# ROCKY FLATS SITE REGULATORY CONTACT RECORD

**Purpose:** Soil Disturbance Review Plan (SDRP) for Regrading the East Perimeter Channel (EPC) and Associated Diversion Berms at the Original Landfill (OLF)

**Contact Record Approval Date:** November 22, 2013

Figure 1. OLF Soil Disturbance, Filling and Grading Location

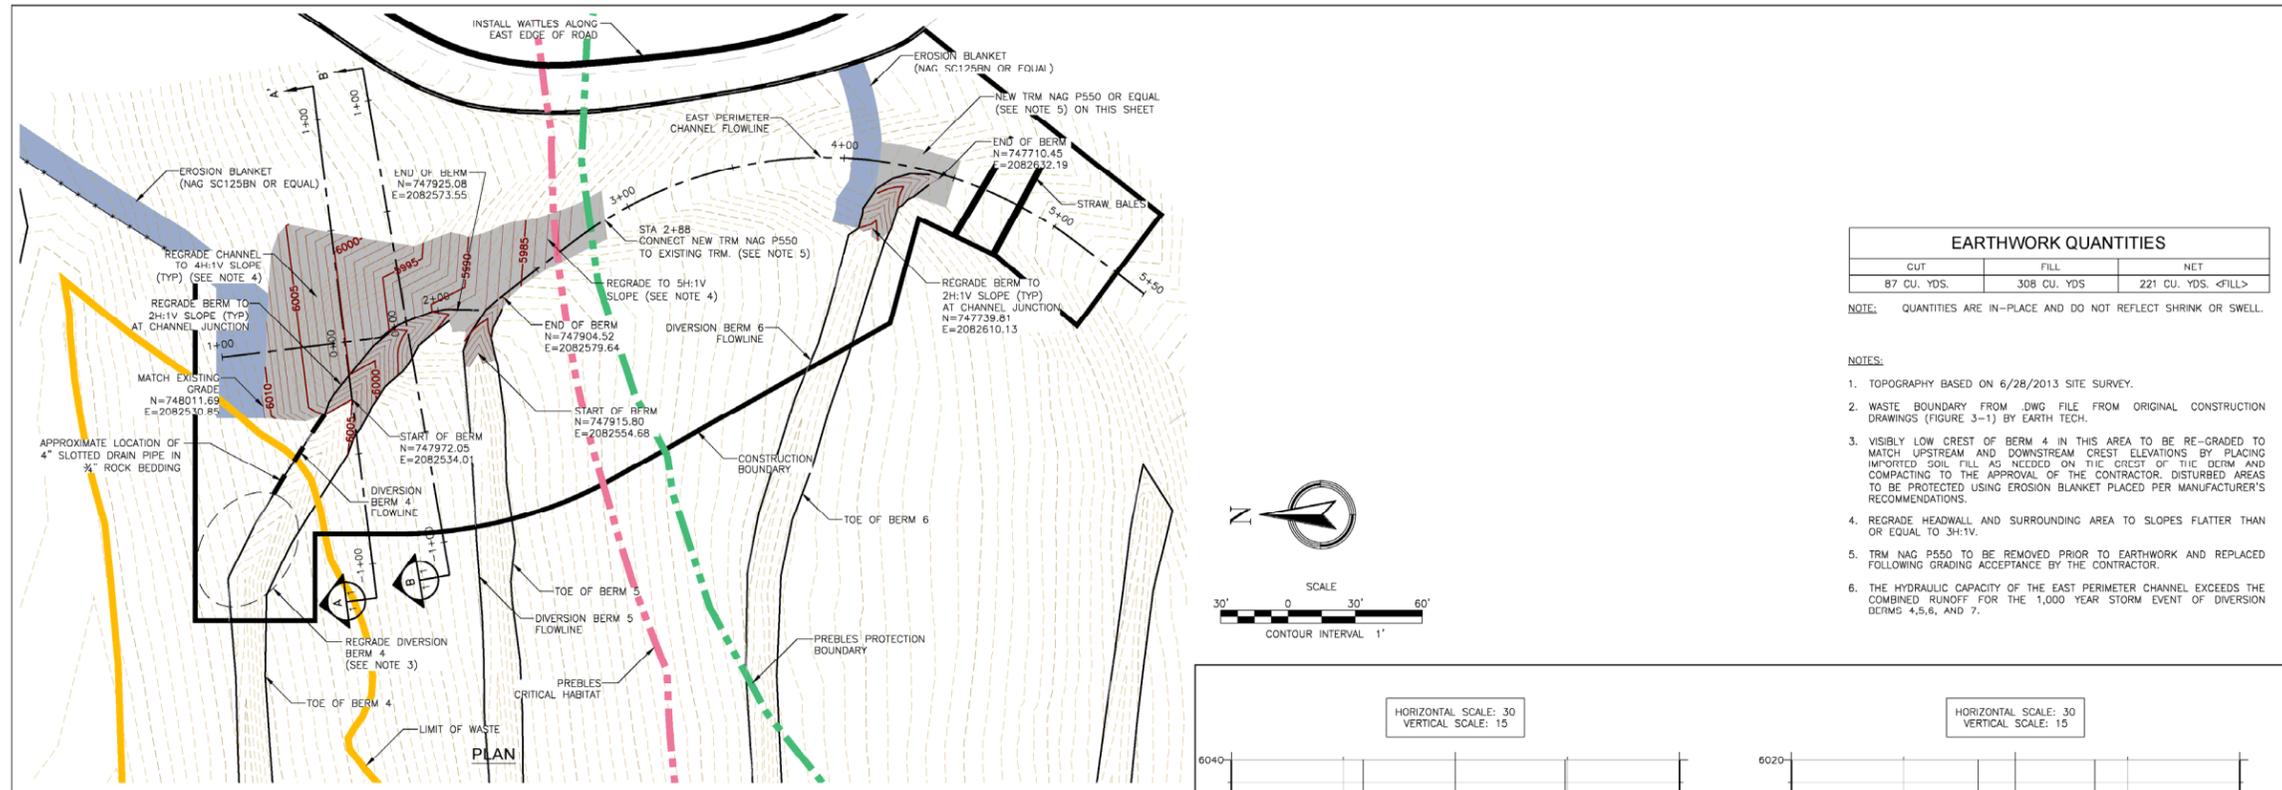
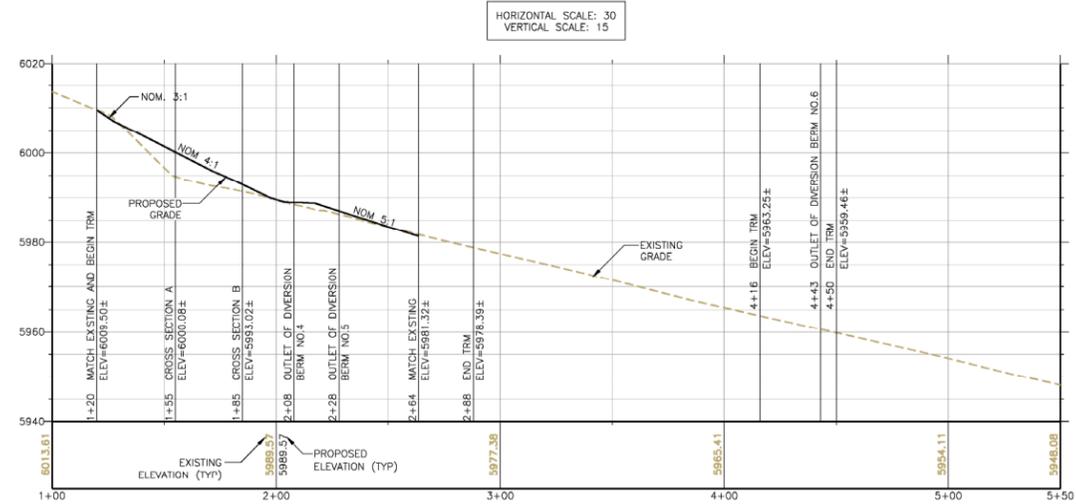
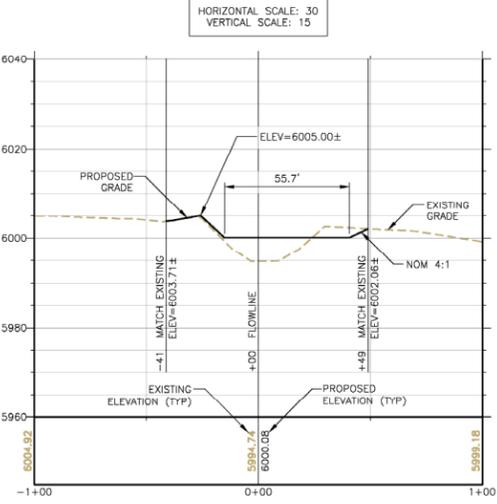
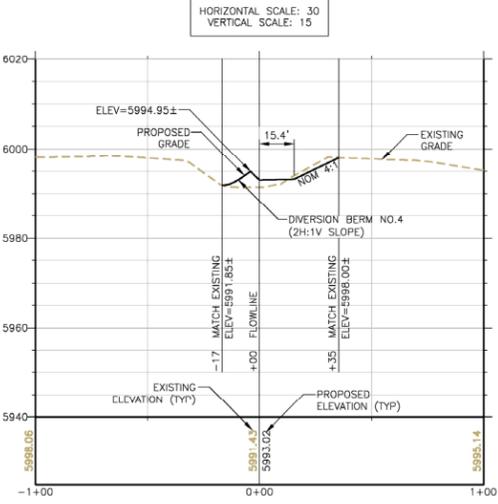
**Discussion:** DOE and CDPHE met on November 19, 2013, to review DOE's proposed grading plan which results primarily in raising the EPC elevations but some areas will have slightly lower elevations. Figure 1 shows the location and anticipated aerial extent of the soil disturbance. A slotted drain pipe bedded in crushed rock was installed in the eastern end of diversion berm 4 as part of the initial response to the localized distress (see CR 2013-02) and this will be left in place.

**Resolution:** CDPHE has reviewed information regarding the proposed soil disturbance and excavation and, after consultation with EPA, has approved the proposed activity and the proposed grading plan. CDPHE has determined that the proposed activity will not compromise or impair the function of the remedy or result in an unacceptable release or exposure to residual subsurface contamination. CDPHE has also determined that the proposed project meets the rationale and objectives of ICs 3 and 6.
